Re: Village at Totem Lake, Wetland and Stream Delineation Review

The Watershed Company Reference Number: 140622.37

Photo 1: Wetland B, facing northeast

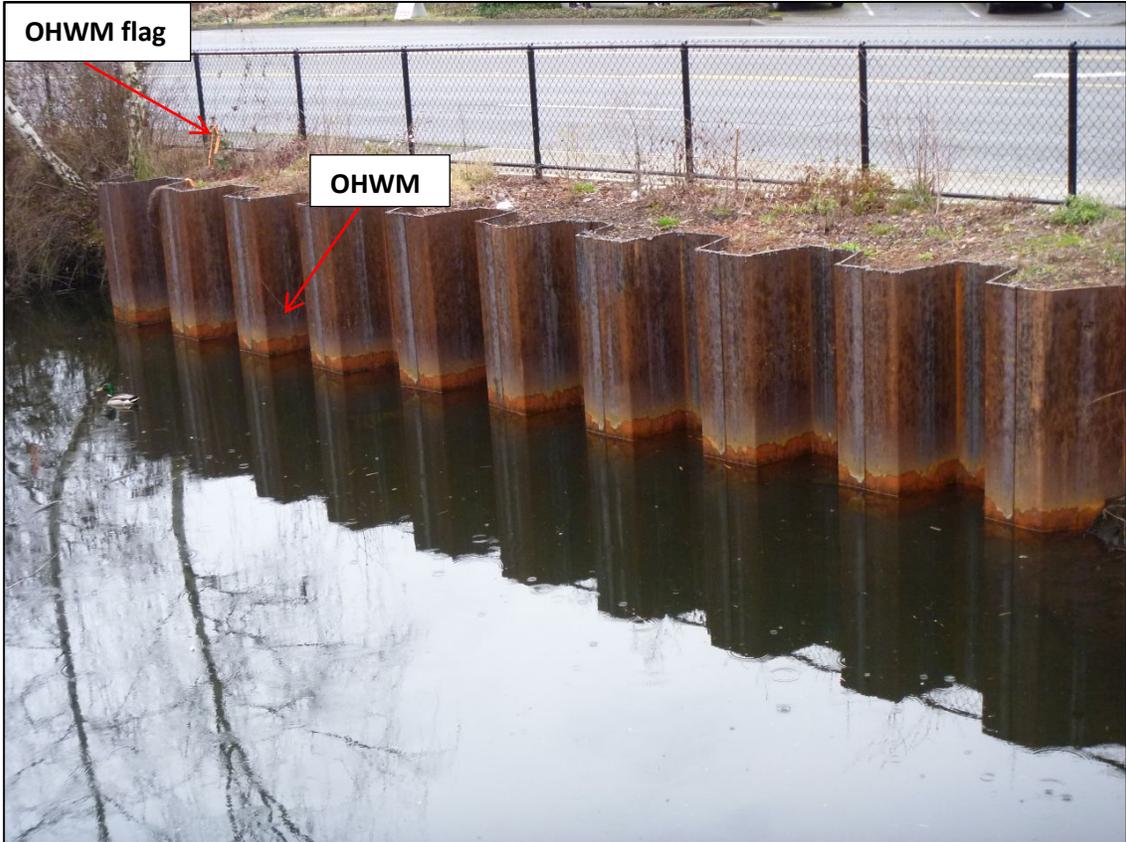
- Question H 1.5. Special habitat features. Talasaea recorded one special habitat feature, “*Invasive plants cover less than 25% of the wetland area in every stratum of plants,*” allocating one point. The wetland also contains “*large, downed woody debris within the unit (>4 inches diameter and 6 ft long)*” (see Photo 1). One additional point should be added to this question, for a total of two points.

Photo 2: Stream 1, south (left) bank, facing southeast

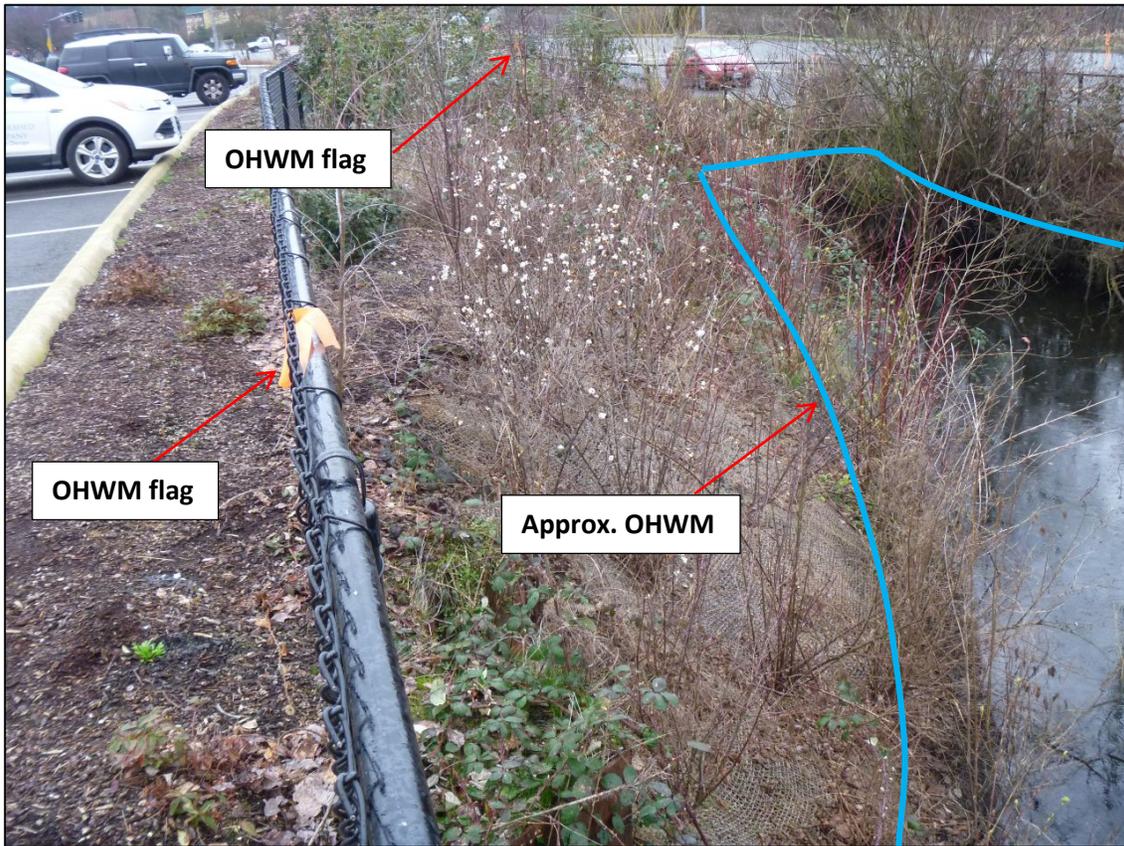
While we agree with the classification of Stream 1, the OHWM flags placed by Talasaea are generally too far outside the channel, particularly along the northern (right) bank. Several of the OHWM flags are tied to the fence surrounding Stream 1, and the majority of those tied to vegetation are significantly higher than the OHWM, encompassing most of the vegetated area within the fencing. As evidenced by the water marks on the sheet piling in Photo 2, the OHWM is approximately one to two feet outside the water levels present during the review inspection. Several of the Talasaea OHWM flags are located five to six feet above the water levels on the north bank (Photo 3). The OHWM flags should be relocated to more accurately reflect the existing condition.
